**SP AusNet Revenue Determination:
Technical Review**

**Findings on SP AusNet's Revised
Revenue Proposal**

**Report to
Australian Energy Regulator**

January 2014

Figure 3: *Asset works actual and forecast expenditure*

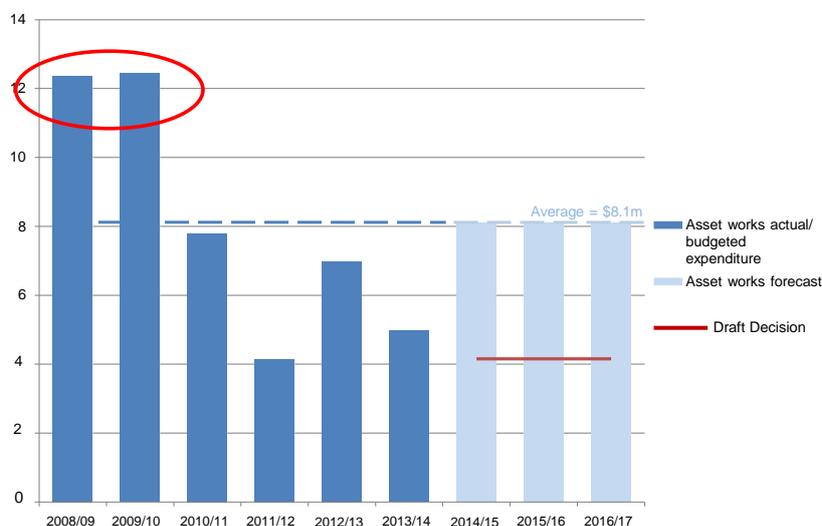
179. With the above discussion in mind, we have considered the application of a base-step-trend approach. In particular we have considered SP AusNet's proposal that the appropriate future level of Asset Works is best estimated by projecting the average Asset Works expenditure over the current RCP, rather than using the same single base

year as is used to project recurrent expenditure. In its RRP, SP AusNet provides the following graph to illustrate actual and proposed expenditure⁴⁸.

⁴⁸ SP AusNet subsequently advised an error in this graph and in its opex model provided with the RRP, in that the 2013/14 figure should be \$6.1m rather than \$4.9m as shown

Figure 4: Current RCP and proposed Asset Works

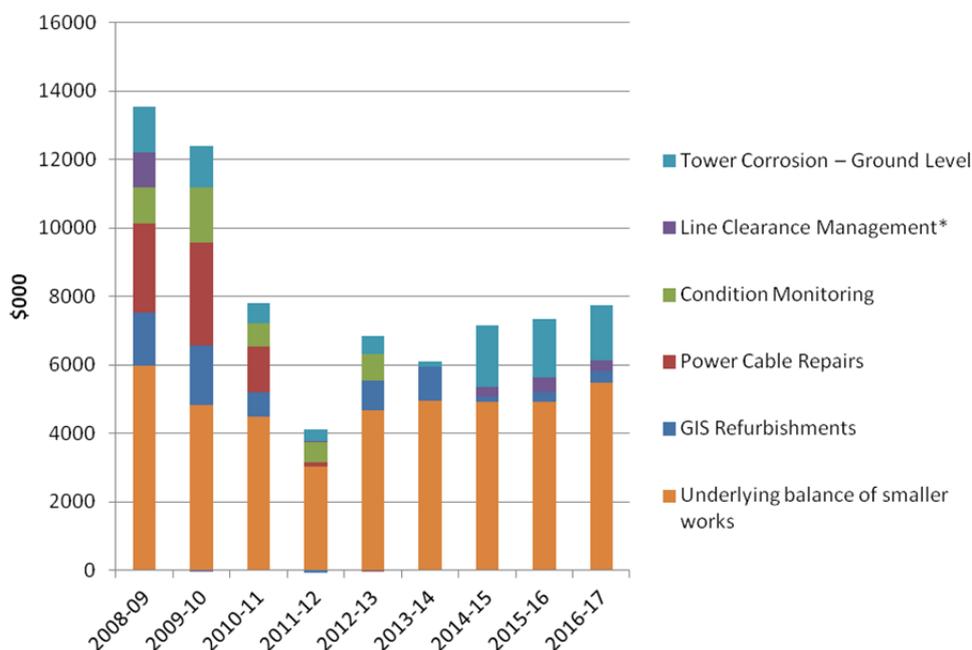
- We transferred the \$8.8m tower painting proposed step change, into Asset Works consistent with our original and current advice, but with SP AusNet's updated cost;

- We reviewed the remaining adjustments that we recommended in our technical review report on the initial RP. Our view is that no new information has been provided that would lead us to change these recommendations.^{50, 51}

Figure 5: Recurrent opex trend and proposed RRP recurrent opex

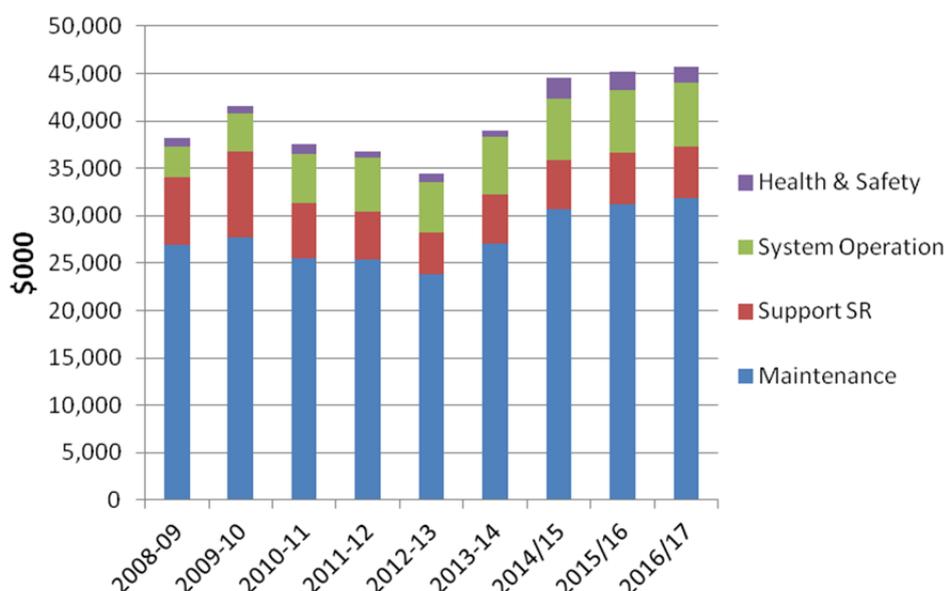
⁵⁷ This would be a continuation of opex efficiencies that are already evident, for example over the years 2010 to 2013 in the current RCP as is shown in figure 5.

Figure 6: SP AusNet current RCP controllable opex, the Draft Decision allowance and SP AusNet’s proposed allowance

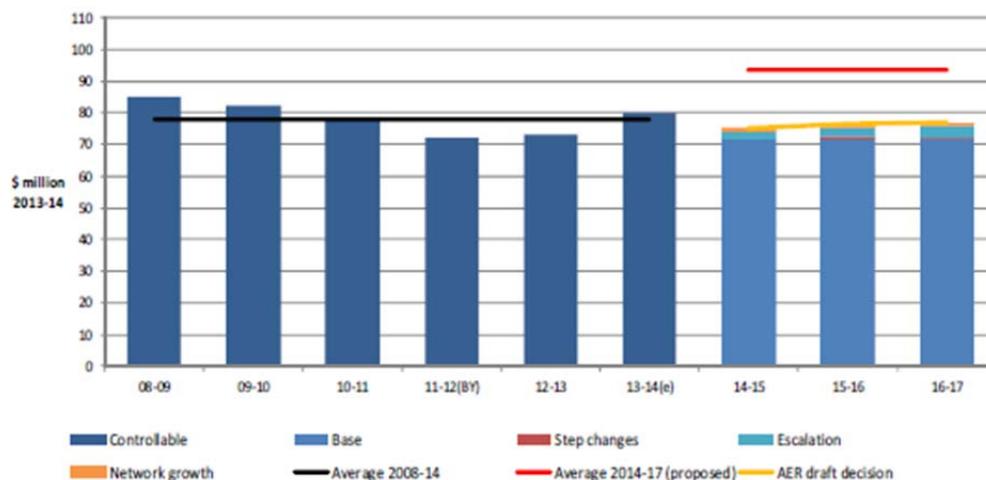
202. The following figure shows the declining level of controllable opex that SP AusNet is incurring over the current RCP (to 2012/13). The allowance in the AER's Draft Decision can be seen to lie within the range of opex that SP AusNet has incurred in the most recent past, that is, since 2010/11.

Figure 7: Categories of proposed Asset Works expenditure⁶²

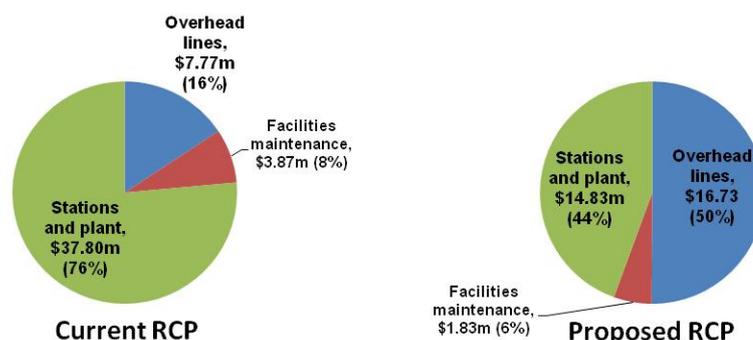
205. In its initial RP, SP AusNet proposed a number of Asset Works programs in three categories, as is shown below, alongside the expenditures incurred in the current RCP. It can be seen that the Asset Works program that SP AusNet proposes represents a major shift in focus from stations and plant, to overhead lines such that proposed expenditure on overhead lines will be similar to that of the ‘risk-stabilised’ stations & plant.

206. The proposed expenditure on Stations & Plant is designed to maintain the risk profile at the current level, noting that the focus of the Asset Works investment in the current RCP has been to reduce risk in this category. With the exception of SF₆ leakage⁶³, reducing reliability and safety risk (from asset failure) are the key objectives in this category. As discussed in Appendix B, the SF₆ leakage mitigation work has not delivered the expected benefits and we consider it is likely that SP AusNet will need to revisit its strategy (including the forecast expenditure).

⁶² For the pie chart showing the expenditure breakdown proposed for the next RCP, we have included SP AusNet’s proposed step change for tower painting, both for reasons of comparability (since it is included in Asset Works in the current RCP figures) and because we recommend that it remains in Asset Works for the next RCP. It should be noted that current RCP figures are for 6 years, whereas the next RCP covers 3 years.

Figure 8: SP AusNet’s current RCP and proposed next RCP expenditure on Asset Works

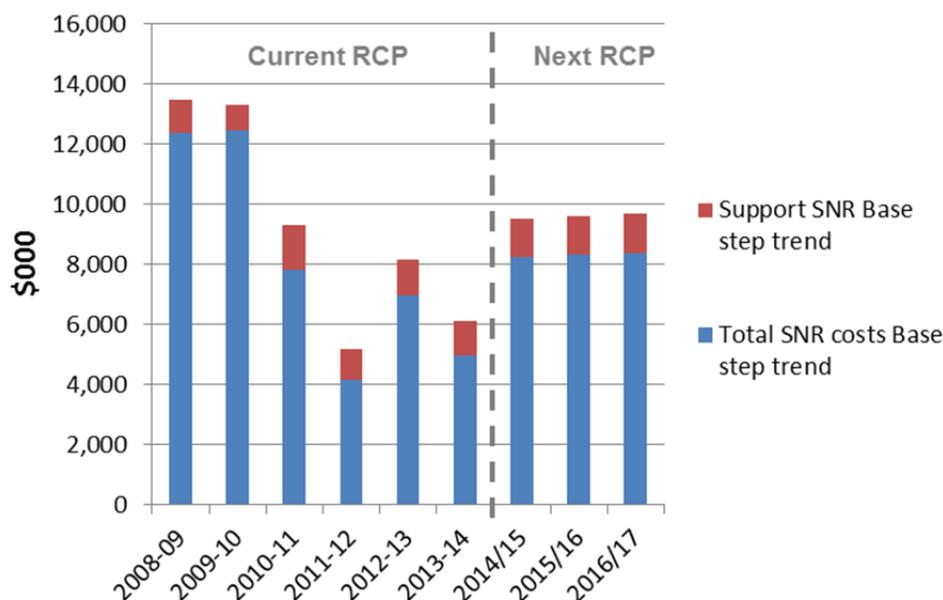
211. We assessed the relationship between SP AusNet’s expenditure levels in the recent past, and its risk profile. We consider that the most relevant opex component for this purpose is Asset Works expenditure, which is shown in Figure 8. This shows the significant drop-off in Asset Works that occurred from 2010/11, with a substantial portion of SP AusNet’s Asset Works program deferred during the most recent four years of the current RCP. SP AusNet also reduced its recurrent opex and further deferred some significant capital works in this time.

Figure 9: Transmission network asset risk

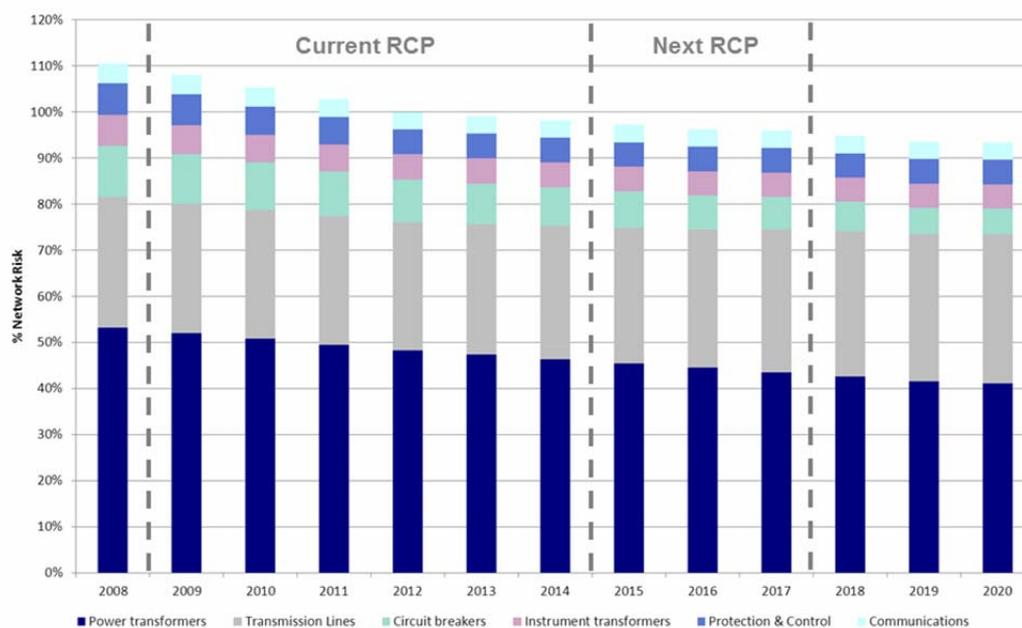
213. Figure 9 shows SP AusNet’s assessment of its time-profile for transmission network asset risk, from 2008 – 2020. The scale of this graph is an index, and shows a declining risk level, including over the period from 2011 – 2014 in the current RCP when asset works expenditure was significantly reduced. This risk profile can also be set against the overall controllable opex profile, which shows a similar (though less prominent) expenditure reduction over the same period.

215. The declining risk profile is consistent with SP AusNet’s statement that the increase in technical risk from [the reduced expenditure] was minimal, with the risk shown as continuing to decline throughout this period.
